THE LIBRARY LOFTS
 90 MADISON AVENUE
 FRISCO, COLORADO

From: [Todd Crowe](#)
To: [Kent, Katie](#)
Subject: Narrative/Response to Comments
Date: Tuesday, October 23, 2018 10:44:15 AM

The following narrative is in response to the various Commission Member comments made during the August 16th P&Z Hearing. I have attempted to consolidated the comments to the topics indicated in bold:

SITE PLAN, CALCULATIONS

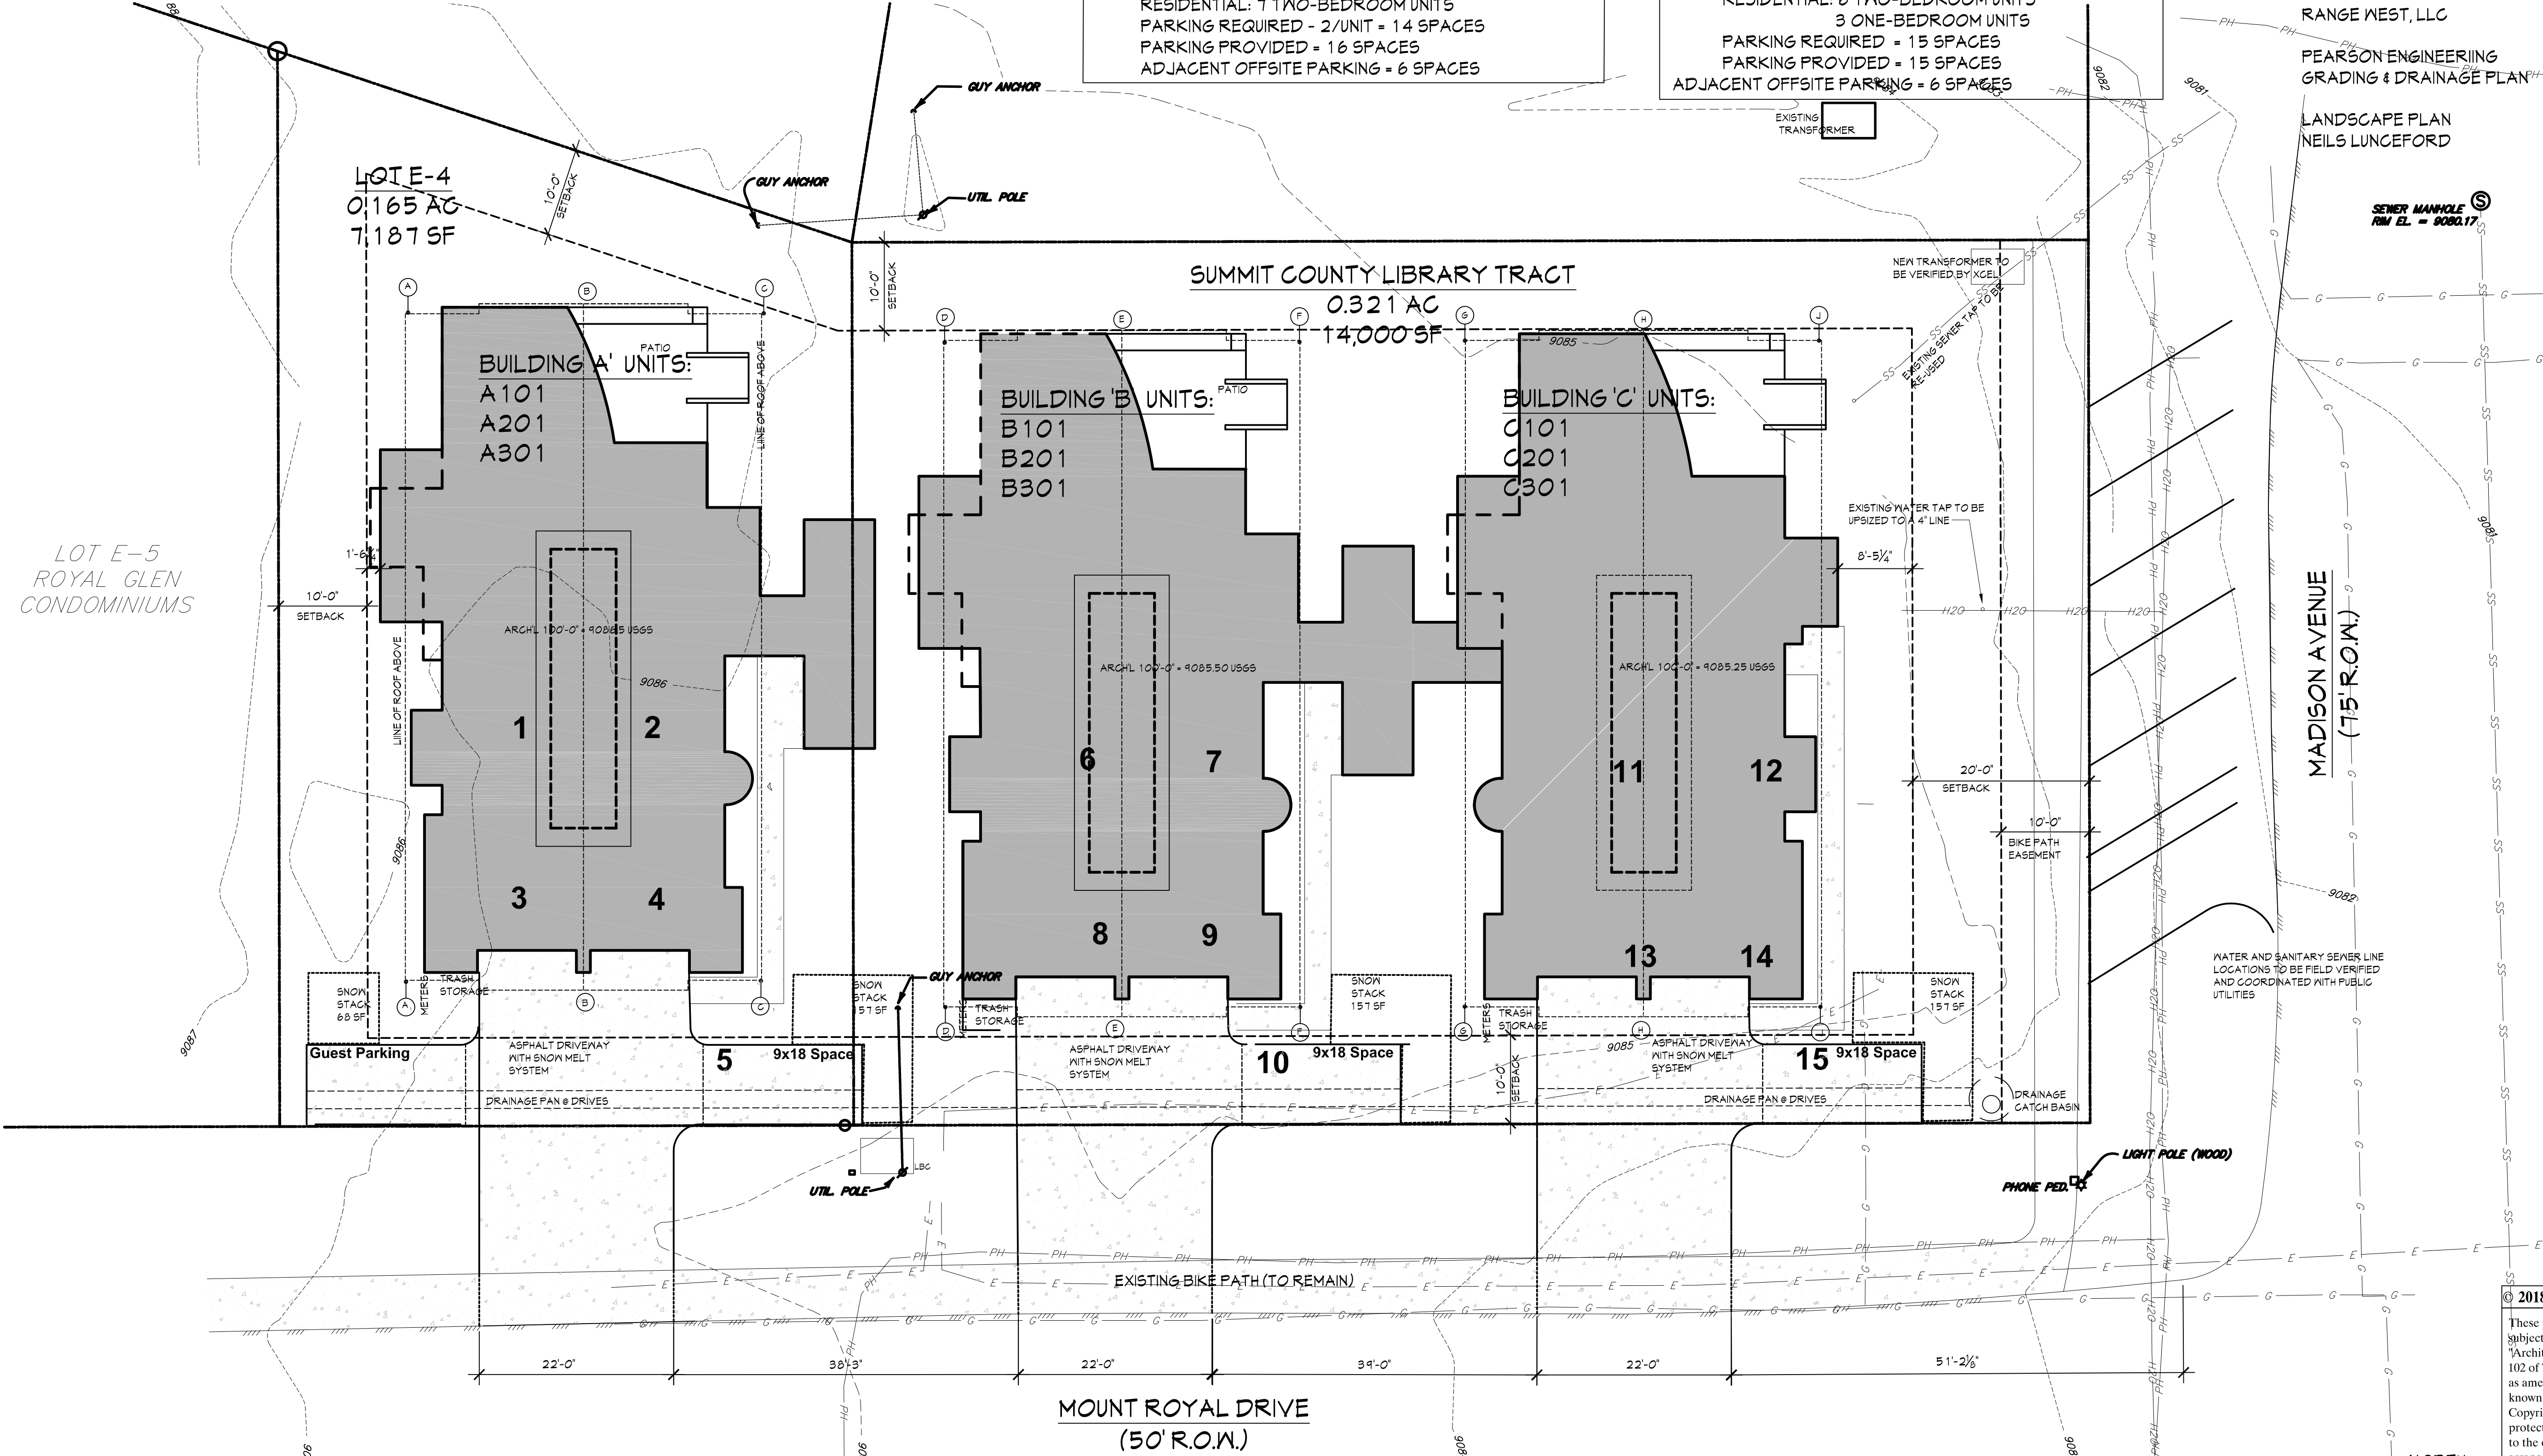
Access/County Engineering:

Separation from Royal Glen:

The configuration of the site has been modified to reduce the driveway area and bring them into compliance with County standards. All site drainage is fully contained on site. All other contingencies identified by the County Engineer have been addressed with the exception of the relocation of the street light which Xcel has agreed to facilitate at their sole expense.

Although the original design was sufficiently separated from the adjacent development, we have responded to the public comment made by Mr and Mrs Tobin, relative to daylight by moving the west unit an additional 5 feet to the east. It should be noted that the east side of Royal Glen is densely treed so while we are happy to accommodate their wishes the primary factor in any diminished daylight would most likely be attributed to the existing dense stand of trees, as depicted in the attached photograph.

COMPOSITE ELEVATIONS

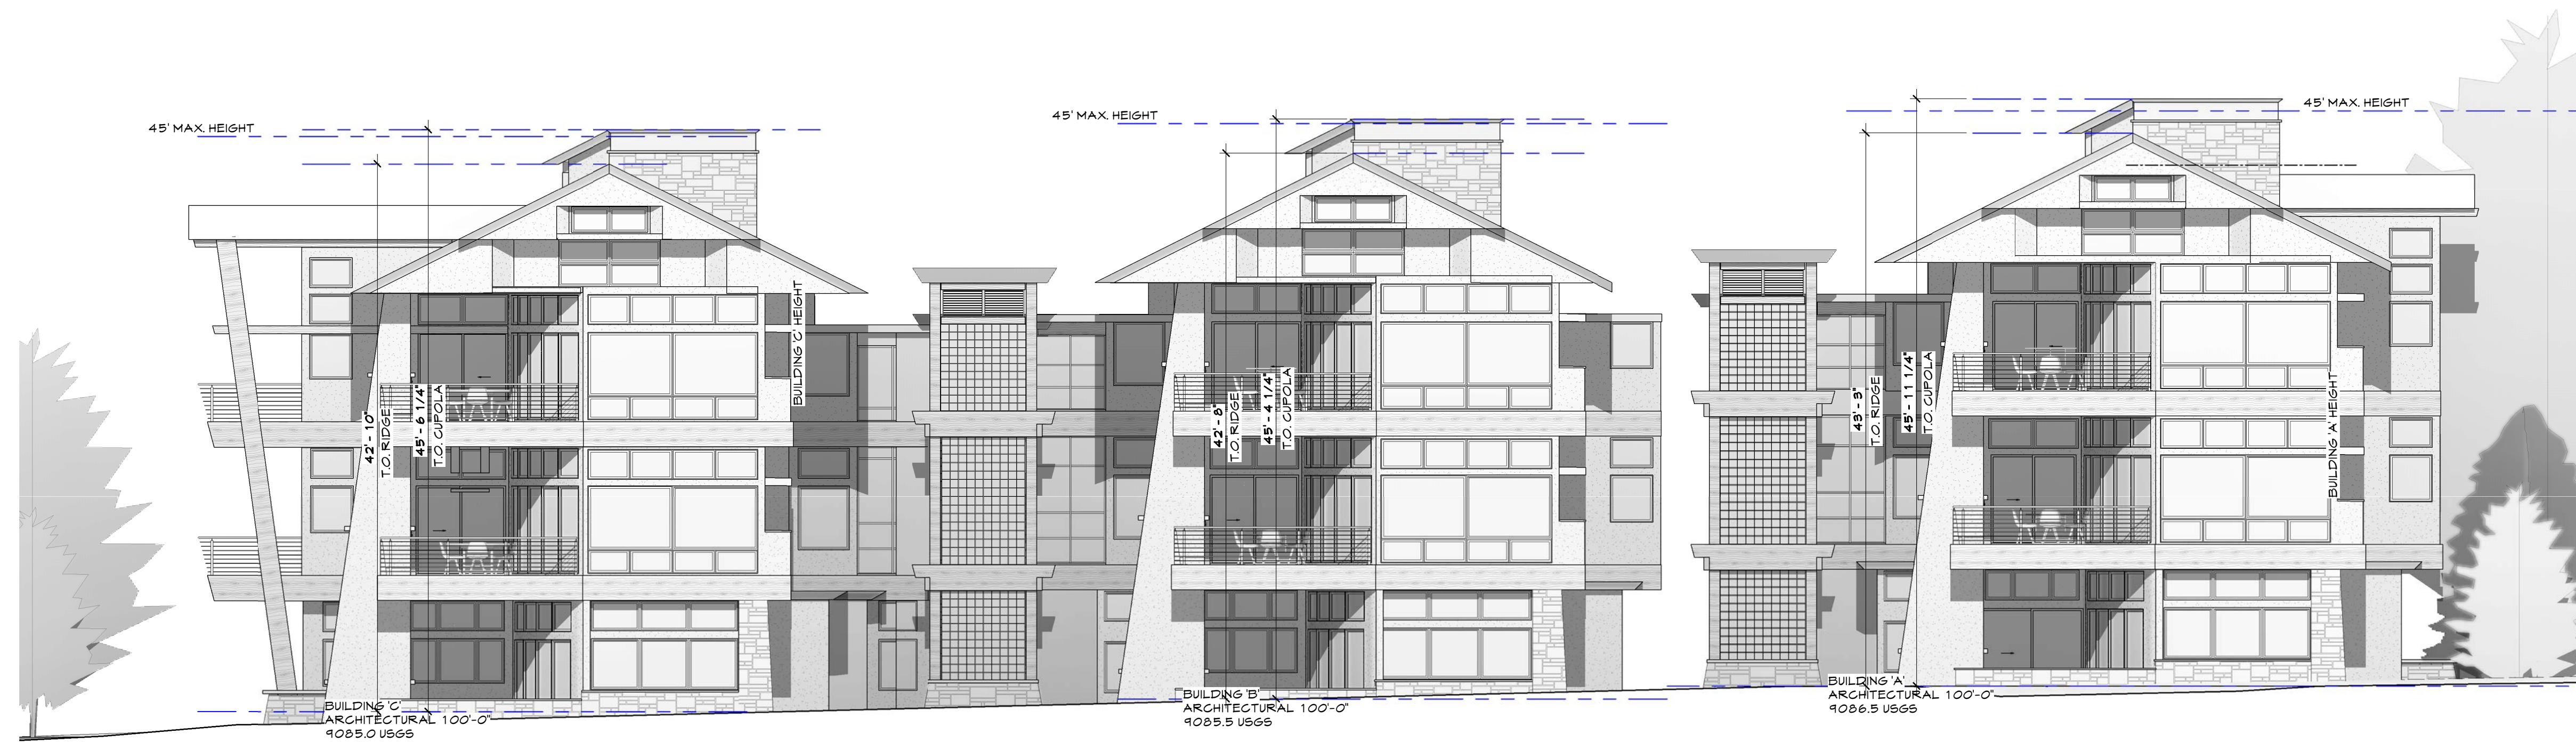
Design Duplicity:

The configuration of the project has been redesigned eliminating the three separate buildings in which the east and middle unit have been integrated, per the originally approved application, thereby creating two distinct structures that are unique to one another. In addition a heavy timber gable element has been incorporated on the east elevation to further articulate the east facade and to differentiate it from the other units...this gable element also serves as an entry focal point to the main level unit and in turn interrupts the roof form. Although the code requires that the ridge line be varied we feel this provision has been complied with given the introduction of this gable element as well as the degree of articulation of the building, as was acknowledged and approved in the original submittal. When critiqued as a “whole composition” and in context with the promontory nature of the site, the interruption of the ridge will only serve to detract from the simple and reposed roof profile which acts as an organizational element that unifies the design....form follows function. In addition the project should be evaluated dynamically not statically as is the case in 2D elevations...from a public perspective the project is always approached diagonally whereby the ridge line will never be evident, in light of such the project will be experienced interactively whereby the composition of the design will unfold as one moves past the residents.
